SMOG 2 WFS Discussion

24-Sept-2020

Buckling WFS (picture: P. Di Nezza)

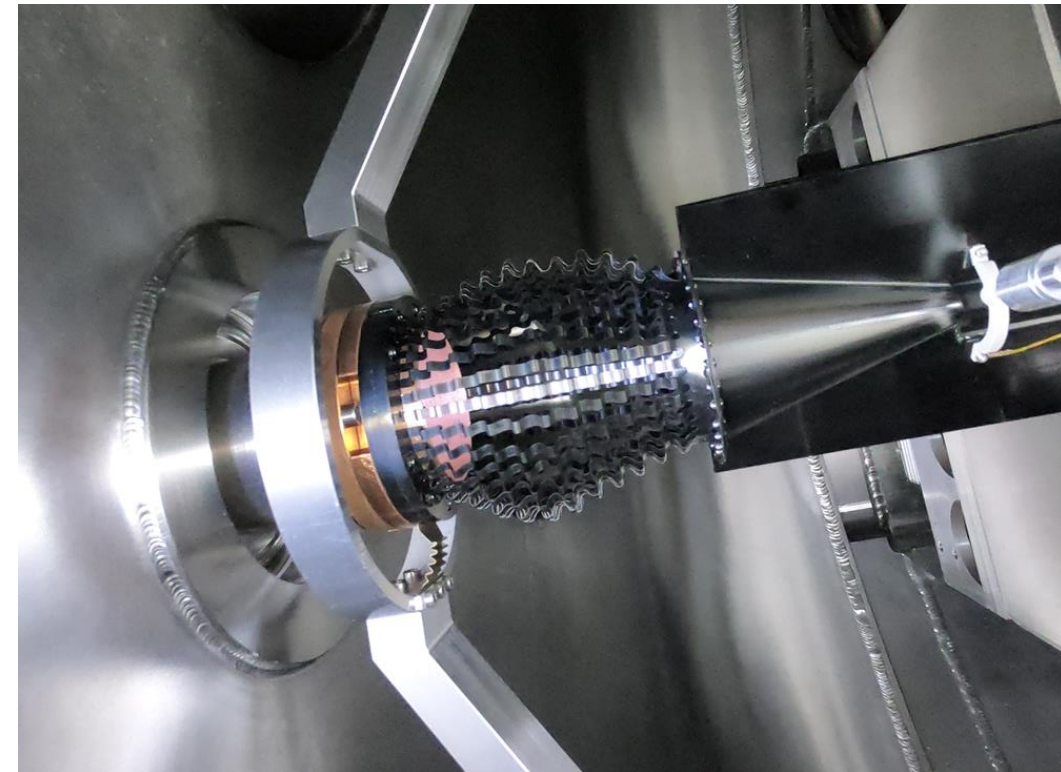
SMOG2 wake field suppressor (WFS) installation is not as expected (fingers buckling and twisting as observed on pictures). We recommend that the nominal situation with a cylindrically shaped WFS is restored to start Run 3 in good conditions.

WFS – additional pictures (1/2)

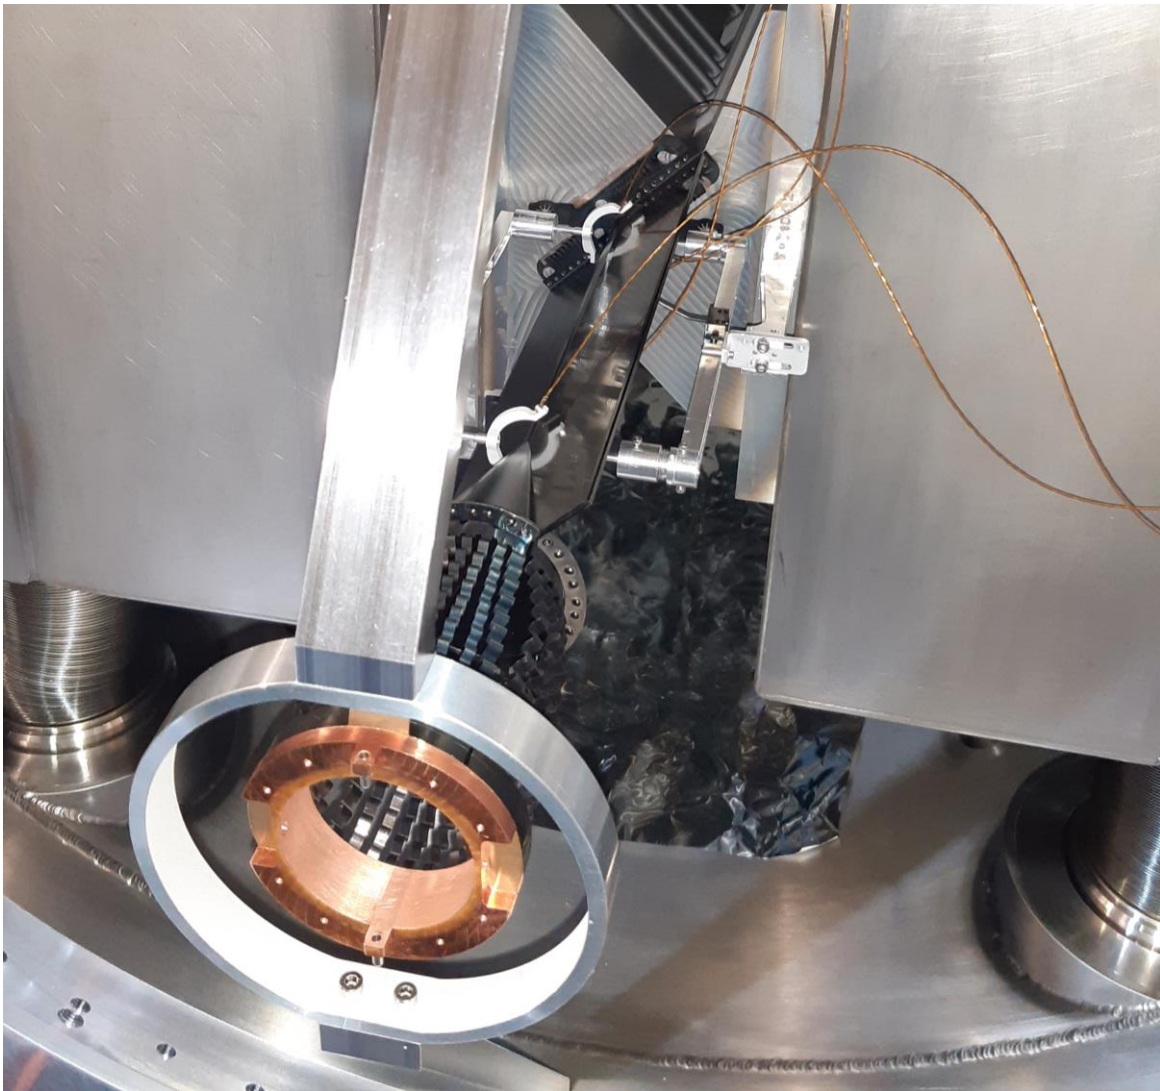
- What is the chance that the WFS keeps its shape and survives all movements during LHC run?
 - mechanical movement during each fill.
 - if fingers are ripped off, could they bend into the aperture?
- Is there a risk to LHCb or LHC run if the Smog 2 WFS fail?
 - Awareness of the problem to be given to LHCb (**inform Rolf or Massimiliano**).
- Was the twisting angle of the fingers observed during test installation already and has this been taken into account?
 - there was no full prototype which would have allowed us to identify these problems beforehand
 - but the cycling tests already included the sideways movement of the Smog 2 cell.
- It would be worth to see the calculated stress concentration in the WFS fingers. This in particular since no visual monitoring of the installation is possible, as far as we understand.
- The estimated longitudinal oversize of the WFS is about 2-3 mm.

- If the 2-3 mm longitudinal oversize of the WFS is confirmed, this could be corrected by:
 - reducing of Cu flange would lead to recovery of the WFS length by about 1 mm (can be done without opening of the vessel).
 - “spacing flange” -> compensation flange installed additionally from outside, recovers up to 5-8 mm. Leads to a overcompression of the bellow on the upstream side (see picture).
 - re-doing the entire upstream transition chamber (est. costs ~15kCHF).
- Can the WFS status be checked while installed?
 - Endoscopy will be possible from the upstream side only before run and means venting the Velo (Josef).
- Could additional tests be done on a WFS outside the machine?
- Would an inspection of the WFS be possible by using the existing view ports, e.g. during TS. To be used for regular monitoring, if needed. View port needs to be modified to allow this method.
